WV ACE Partial State Plan
Appendix I

R13-3495

**Longview Power LLC
Maidsville
061-00134**

This Final Determination summarizes the comments received on the draft permit, includes responses to the comments, and documents any actions taken or changes made in response to the comments regarding Permit Application R13-3495.

Figure One from Commenter #6. Longview Rolling Annual Average Emission Rates²⁵

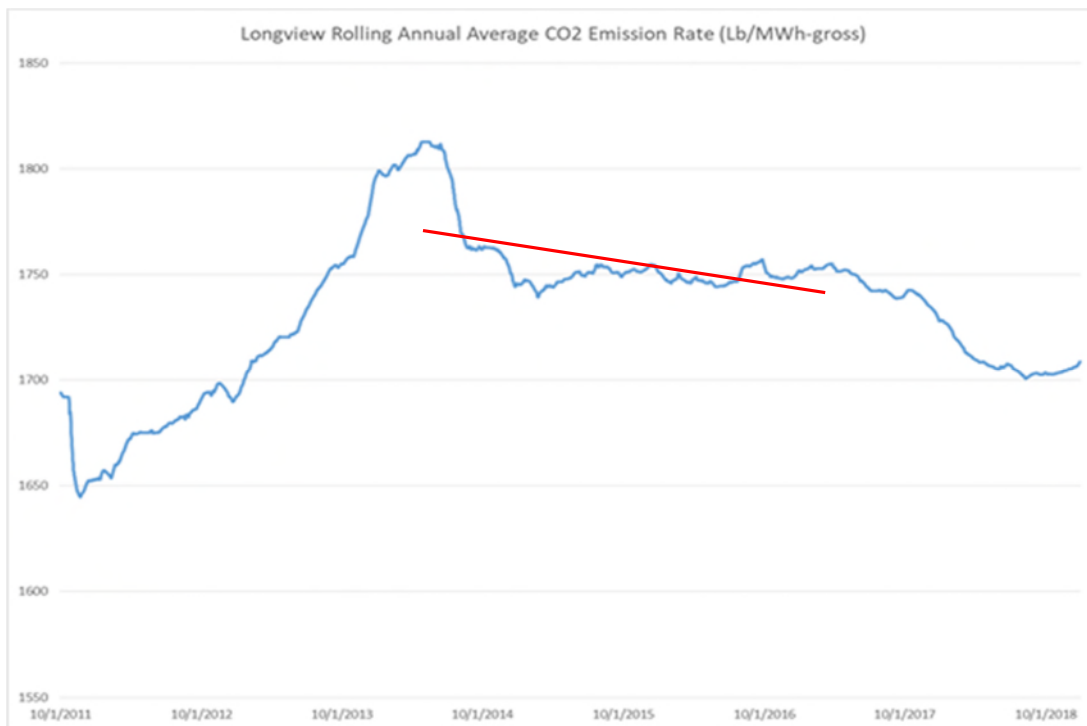
These data (See Figure One, below) also show that, after initial startup issues were resolved, the emission rate improved over time (as some – but by no means all - of the recommended HRI technologies were adopted) rather than degrading. It should also be understood that these rates include operation in all Load Bins and were achieved at a time when Longview's operator was under no obligation to maintain a specific emission limitation and may have found it to be economically rewarding to operate in a fuel-inefficient manner. Thus,

DAQ's Response to Comment #10

Please also see the DAQ's Responses to Comment #1, Ms. Lawson's Comments, and Ms. Rosser's Comments concerning the increase in emissions and the DAQ's Responses to Comment #14, #15, Ms. Barbor's Comments, and Mr. Kotcon's Comments #6 and #7 concerning degradation.

Figure 1: Chart of the Heat Rate of LB-5 for LVP

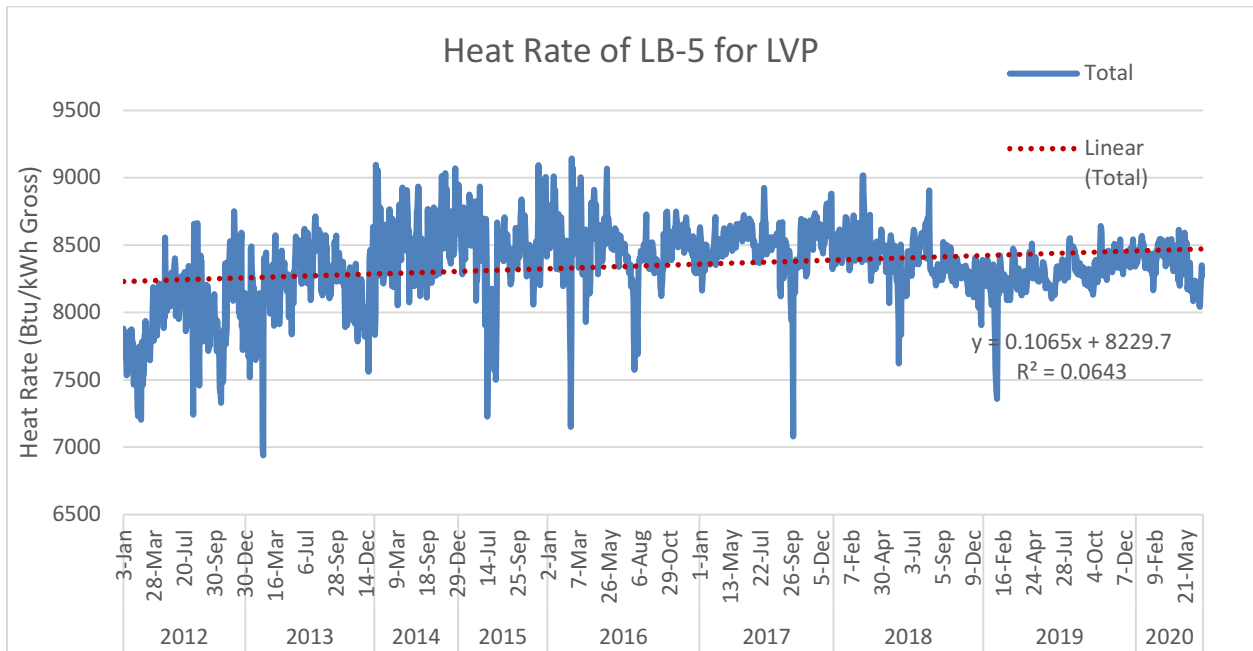
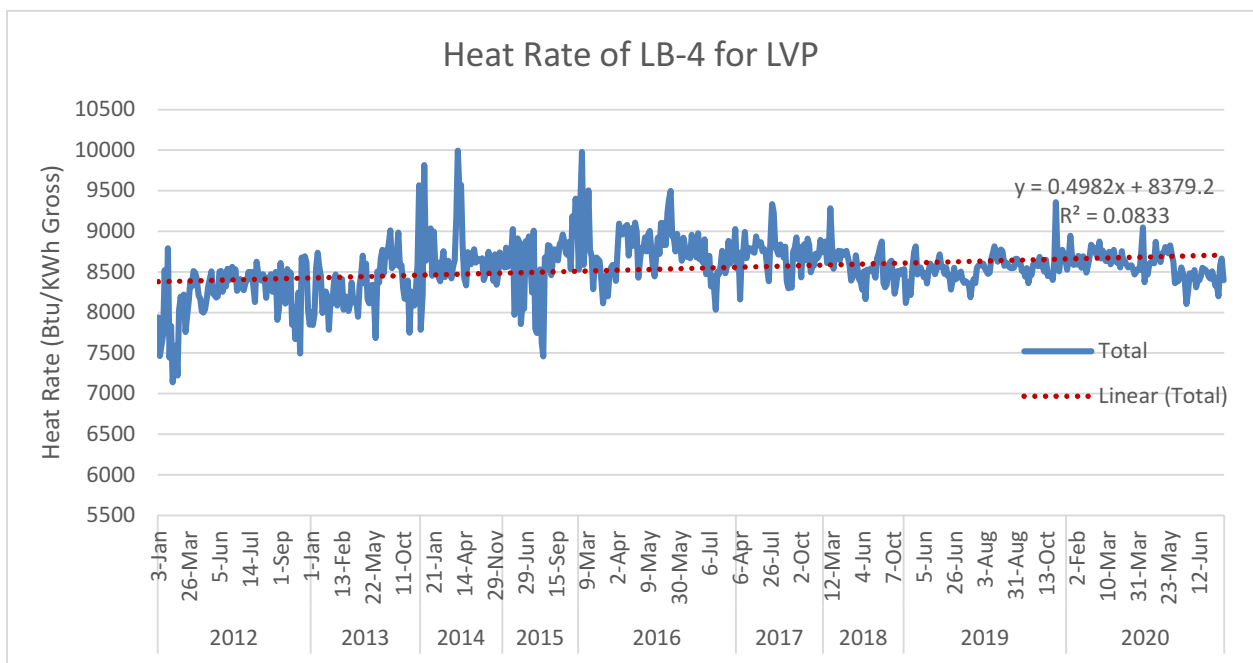
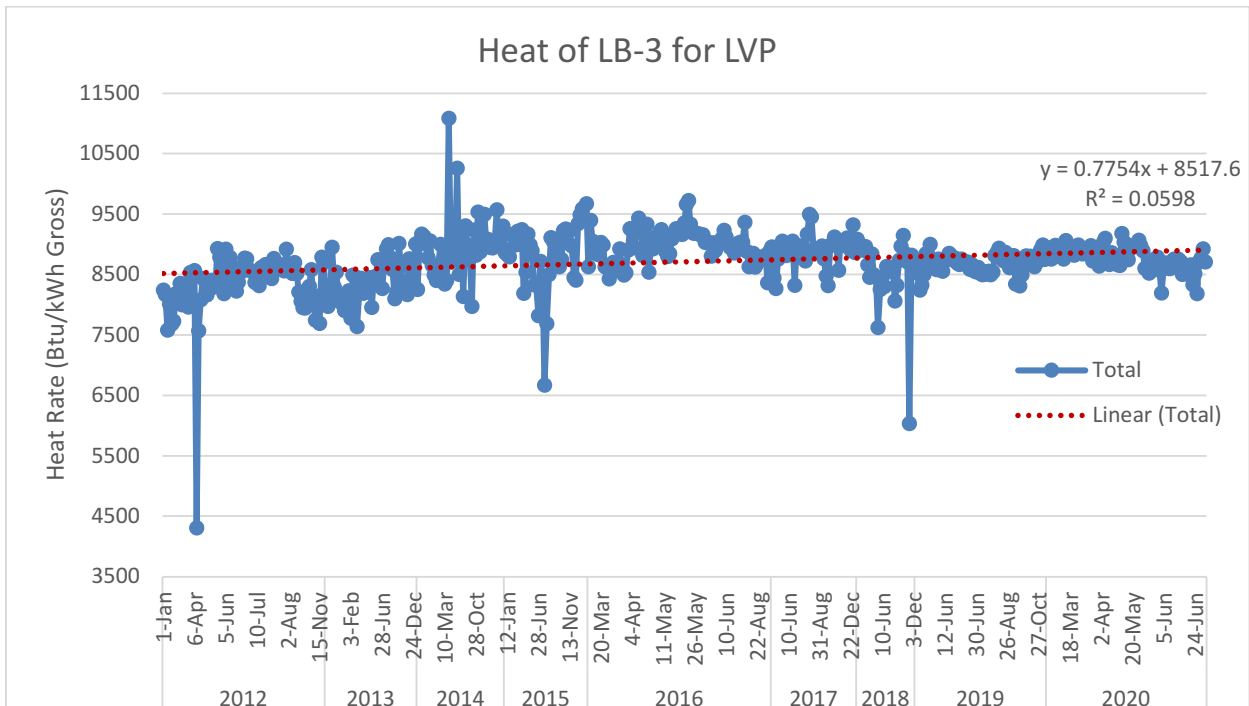
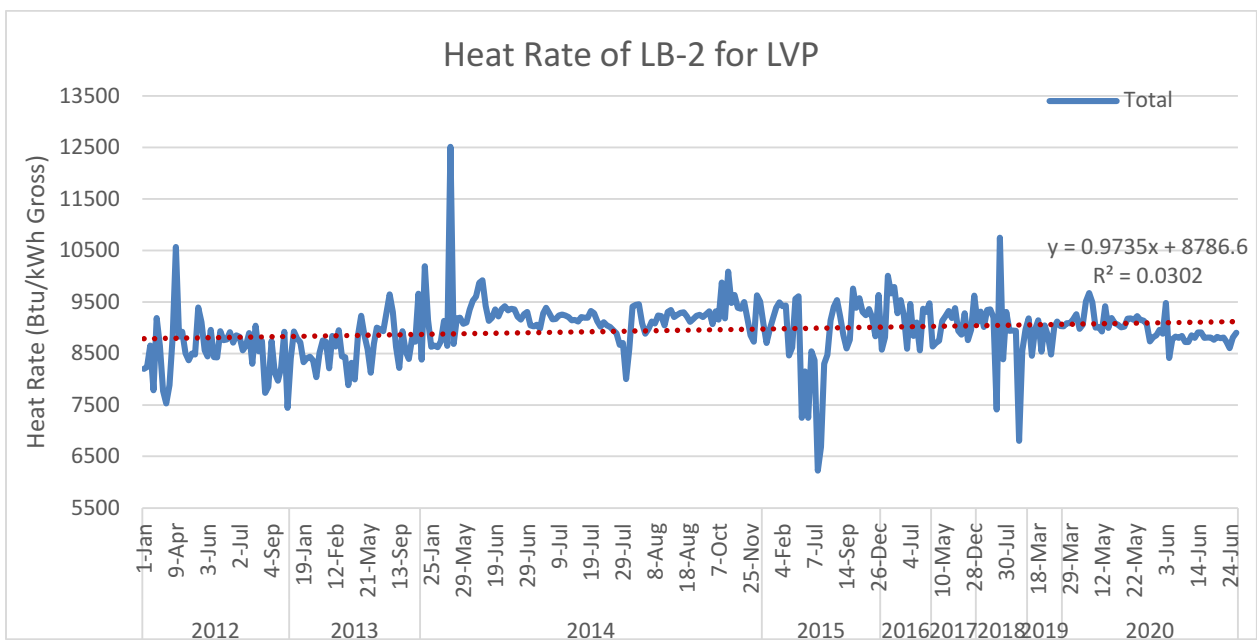
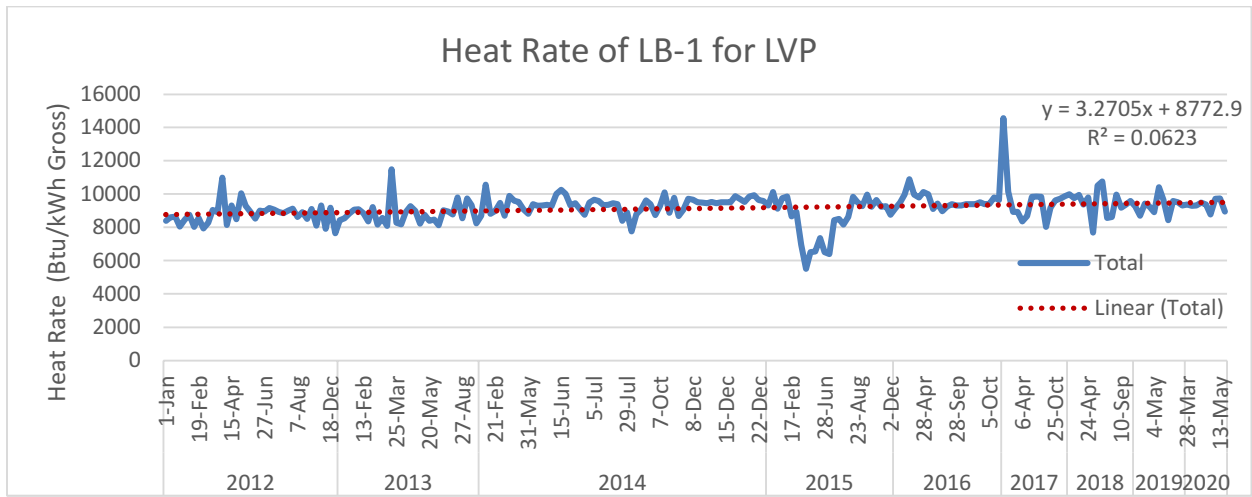
The commenter did not provide any support of their claim that unit degradation is not inevitable.

The DAQ calculated the unit's heat rate on a gross basis from 2012 through 2nd Quarter 2020 by load bin. The following is the daily heat rate for Load Bin 5 with a linear trendline added to the chart.

The trendline indicates that the unit is degrading at a rate of 0.11 Btu/kWh for each operating day, which equates to an increase of 40 Btu/kWh on an annual basis. The other load bins are decaying at a higher rate than Load Bin 5, which are presented in the following charts (see the increase of the slope of the predicted linear function for each bin).

The proposed rate of 0.4% annually equates to approximately 35 Btu/kWh on an annual basis. These charts suggest that Longview Power will be required to find additional improvements to maintain compliance in the future or reduce the degradation rate by improving maintenance of equipment that affects the unit heat rate.

Figure 6: Actual Heat Rate Curve of LB-5 vs. Proposed Heat Rate Curve

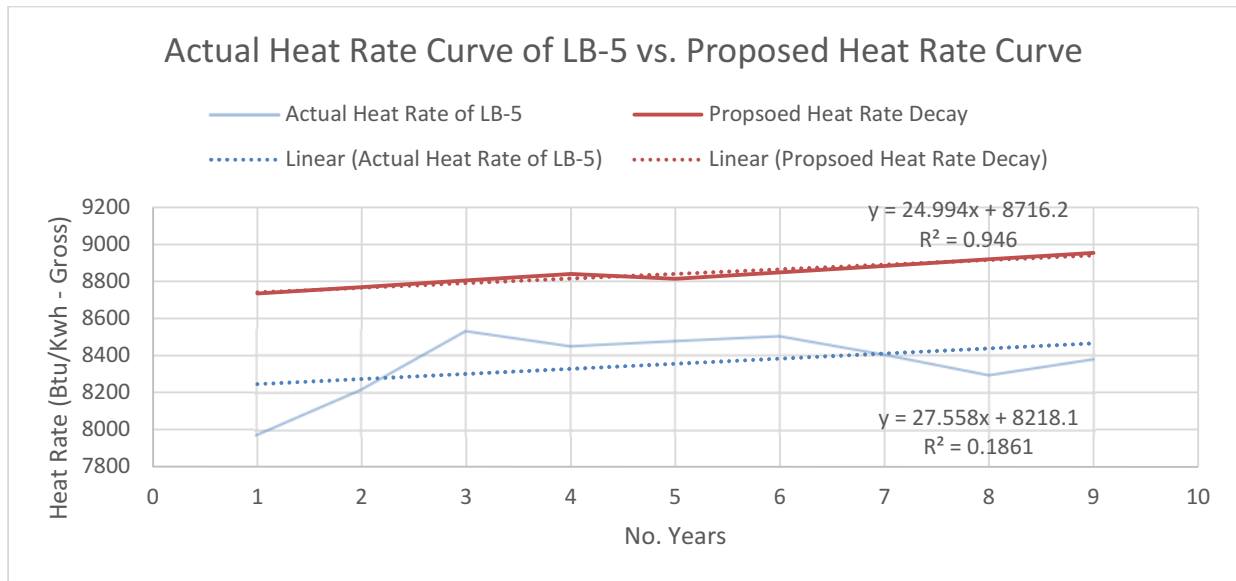
The UDAF also allows the emissions rate increases to compound year-over-year, thus allowing much larger annual increases in later years. There does not appear to be any evidence to justify this, and Figure 20 shows a linear, not logarithmic, increase (even in plants not required to implement Heat Rate Improvements). Since the goal is to limit greenhouse gas emissions, we recommend that the permit use lower rates for UDAF, provide better justification for any non-zero UDAF, and apply them only to the base year, rather than using a compound interest approach as currently proposed.

The DAQ's Response to Comment #14 indicates that the rate of decay (slope) of the actual unit's heat rate is increasing faster than the proposed degradation rate set forth in the permit. (See Figure 6.) From Figure 6, the DAQ understands that Longview Power will have to improve the unit's actual recovery rate order to maintain compliance in the future (e.g., reduce the amount of heat rate that is lost due to equipment degradation) or implement additional HRI to offset the unit's degradation rate.

Figure 8. LVP Total Operating Hours⁵

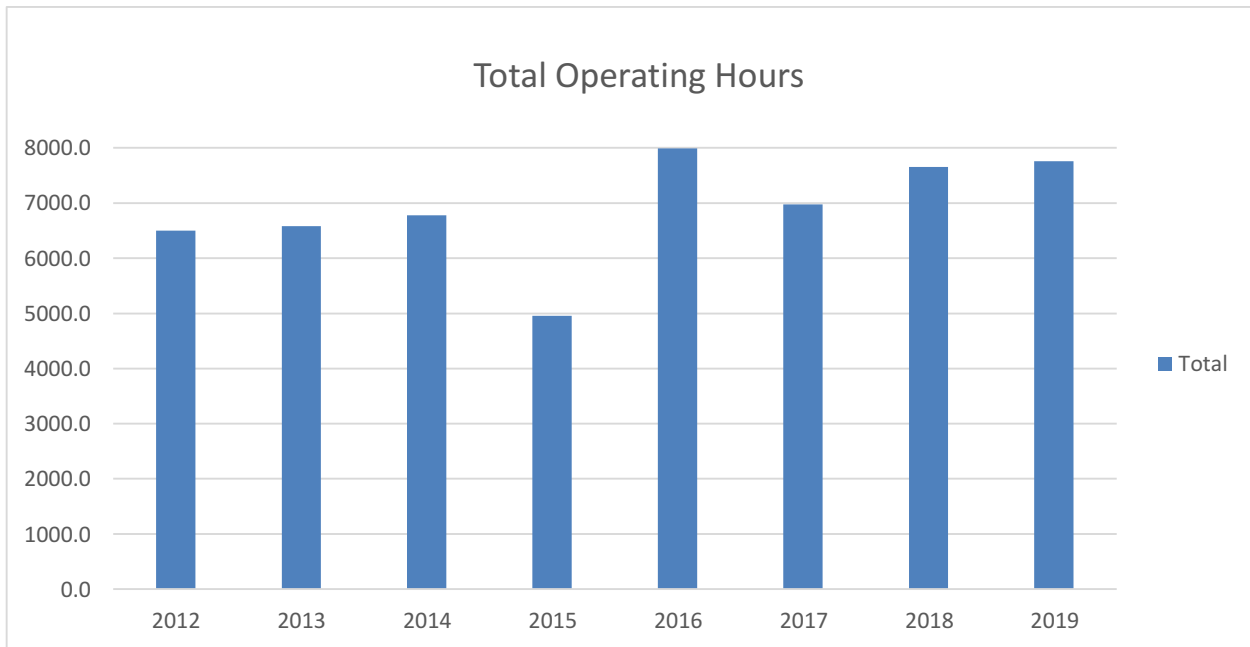
Furthermore, the 2019-2020 data represent a mean over hours of operation that include all of the operating loads. Figure 8 of the EE indicates that Longview operated at something less than 90 % of the time, and Figure 12 suggests that the plant was operating in Load Bin 0 (<40 % capacity) approximately 50-100 hours in 2019 when would have the highest emissions rates, and had a significant number of operating hours in Load Bins 1-4 in 2019-2020. Table 4

As noted by the commenter, 1st and 2nd Quarters of 2020 contains emissions data that increase the number of data point for the lower load bins. Longview Power and the DAQ added this additional time to the base period to increase the amount of data for the lower load bins which was needed to allow the use of a cumulative approach to refine the data with an acceptable standard deviation for each of the bins. This additional data by itself would not be sufficient in developing a limit for these lower bins, which will be explained in further detail in this response.
